ARCHITECTURAL REVIEW BOARD MEETING

PROJECT COMMENTS

PROJECT NUMBER: SP2026-014
PROJECT NAME: Site Plan for 5133 S FM 549
SITE ADDRESS/LOCATIONS: 5133 South Farm to Market 549, Rockwall, TX, 75032

DEPARTMENT	REVIEWER	DATE OF REVIEW	STATUS OF PROJECT
PLANNING	Bethany Ross	05/21/2026	Approved w/ Comments

1 ARCHITECTURAL SITE PLAN

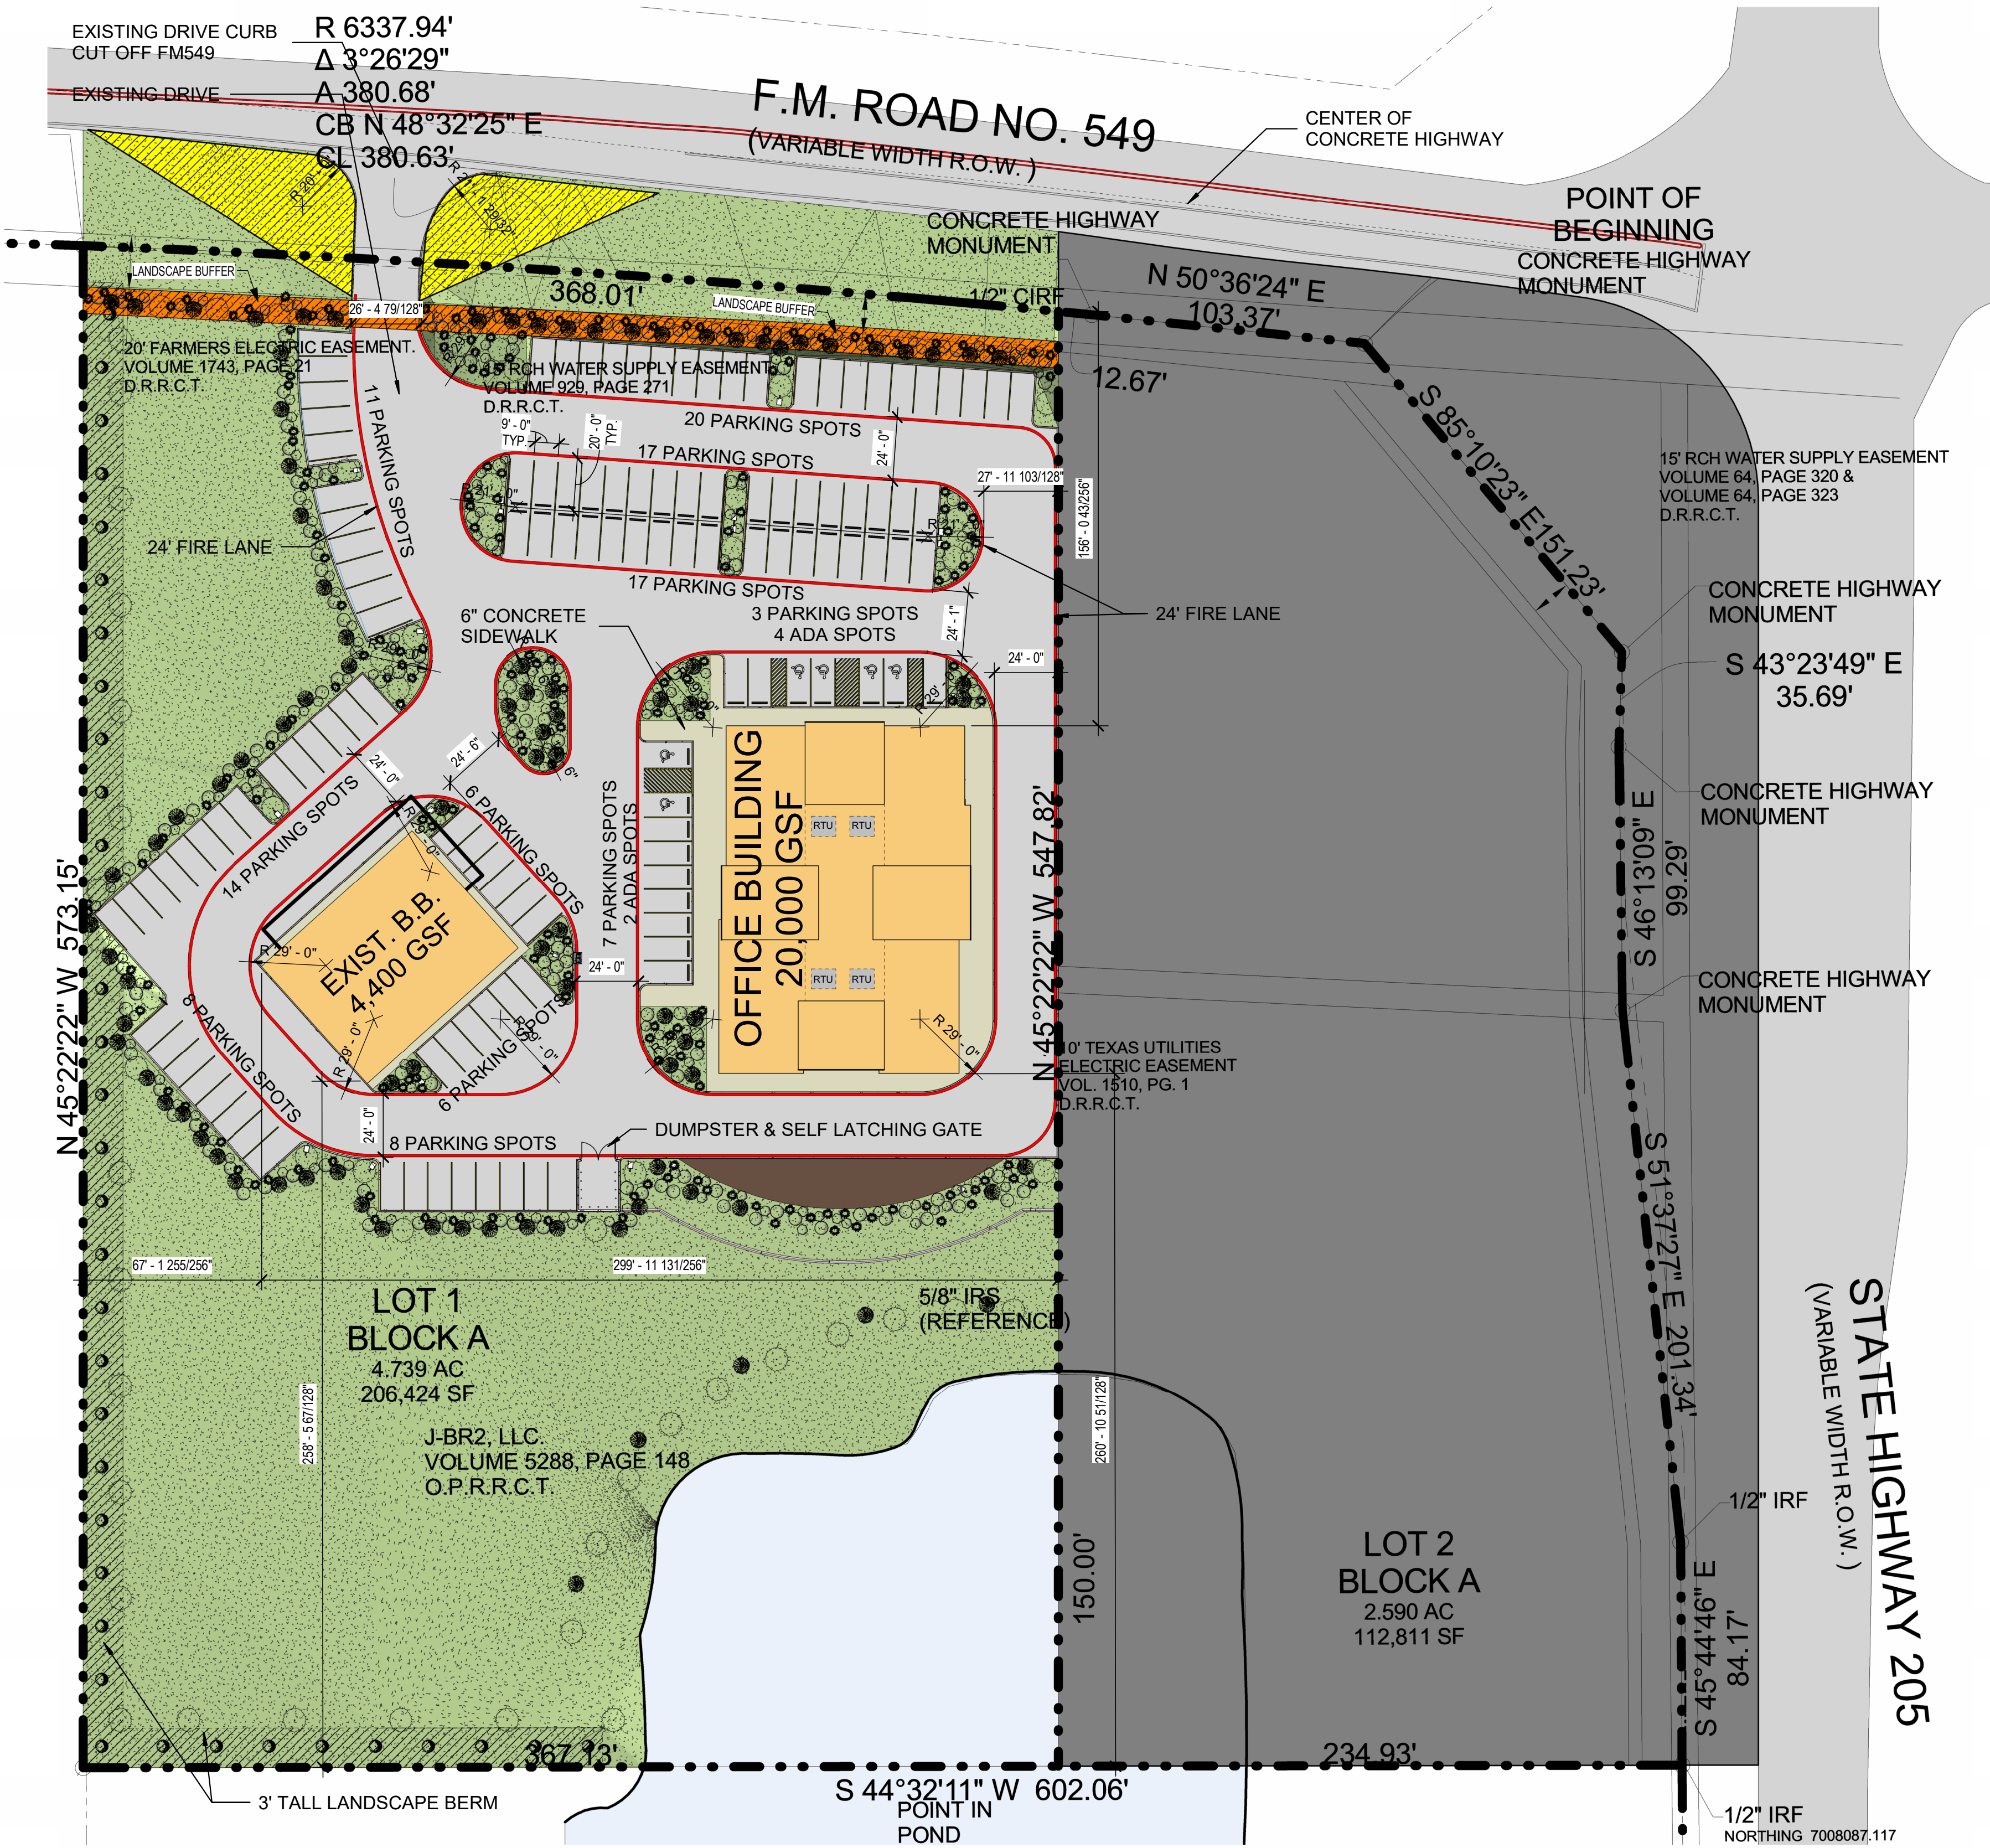
M.7 Site Plan

1) Remove the C-Store entirely from the Plans.

- 2) Provide a floor plan of the existing baseball facility to determine the occupancy/parking requirement.
- 3) Indicate perimeter dimensions of the buildings. (Subsection 03.04.B, of Article 11, UDC)

- 8) The parking calculations appear to include parking that is not on the subject property and does not consider the existing structure on the subject property. Please correct the parking calculations and ensure that sufficient parking has been provided. Office is parked at 1/300 SF. Indoor Commercial Amusement/Recreation is parked at 1/3 Occupancy. (Subsection 06.05, Article 05, UDC)

1 PHOTOMETRIC PLAN

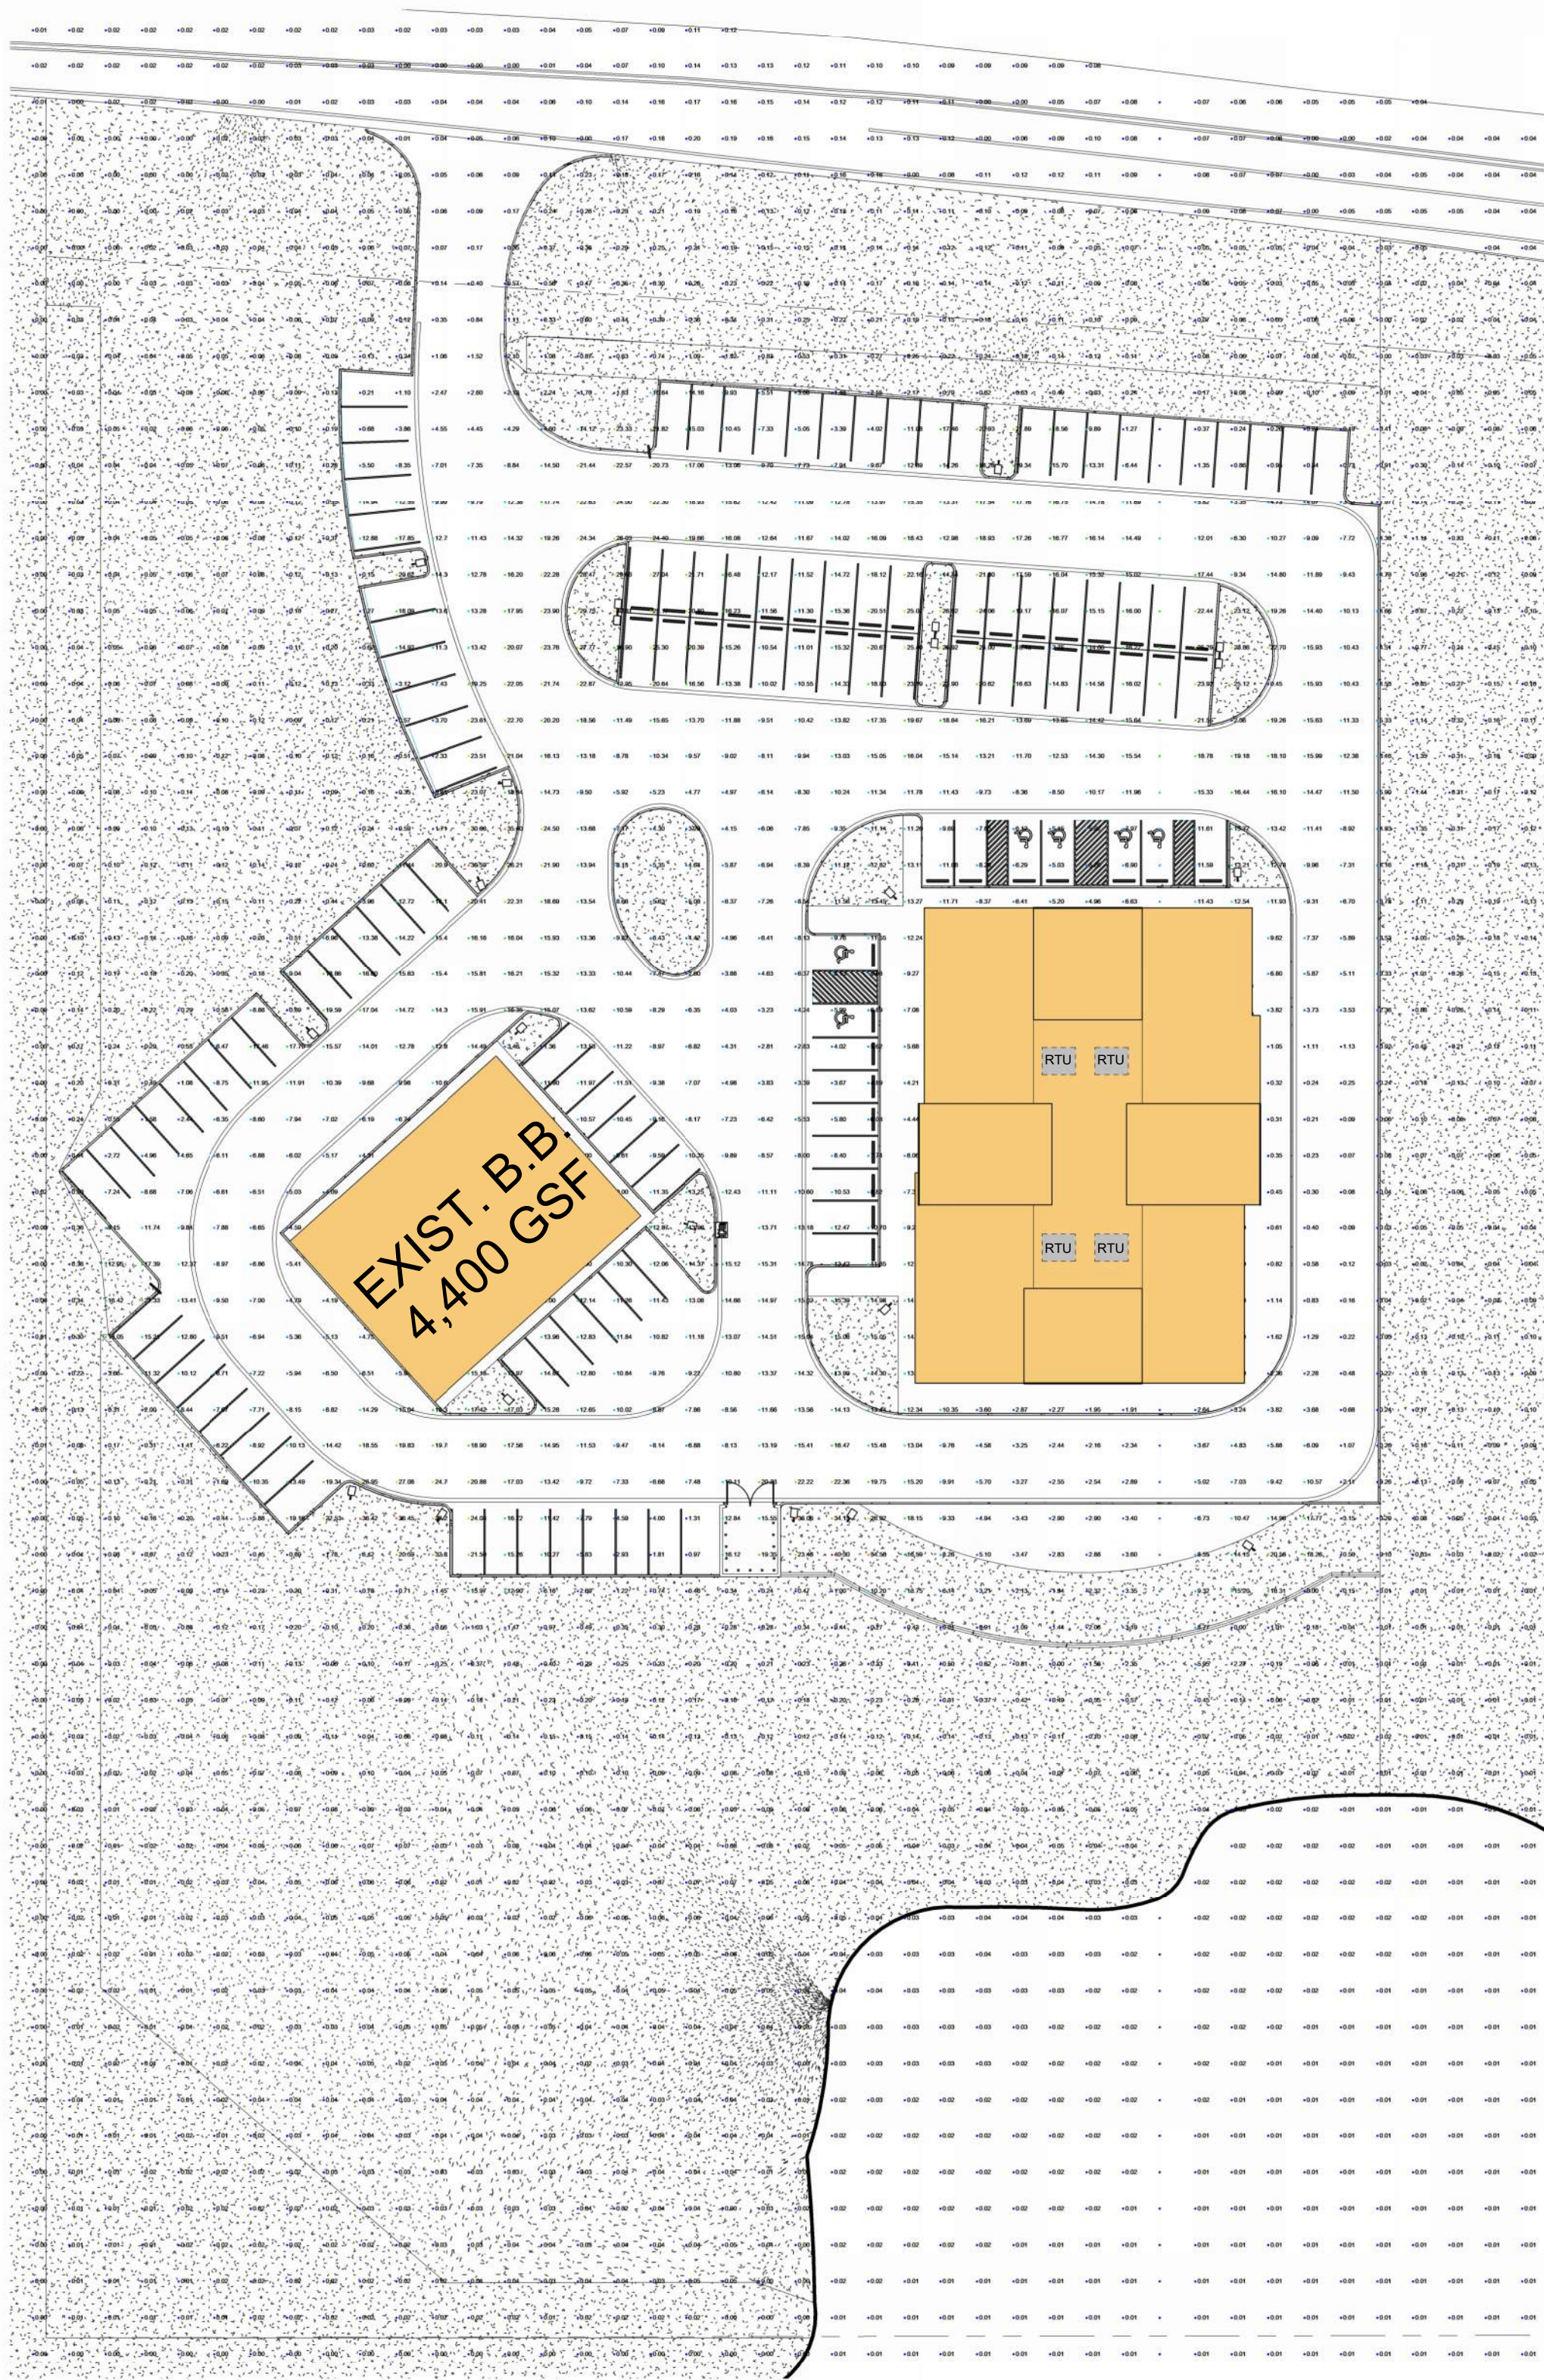
M.10 Photometric Plan

1) The allowable maximum light intensity measured at the property line of a non-residential property is 0.2 FC of one footcandle. (Subsection 03.03.C, of Article 07, UDC) The light levels along the northern, eastern, and western property lines exceed the maximum values. Please correct this.
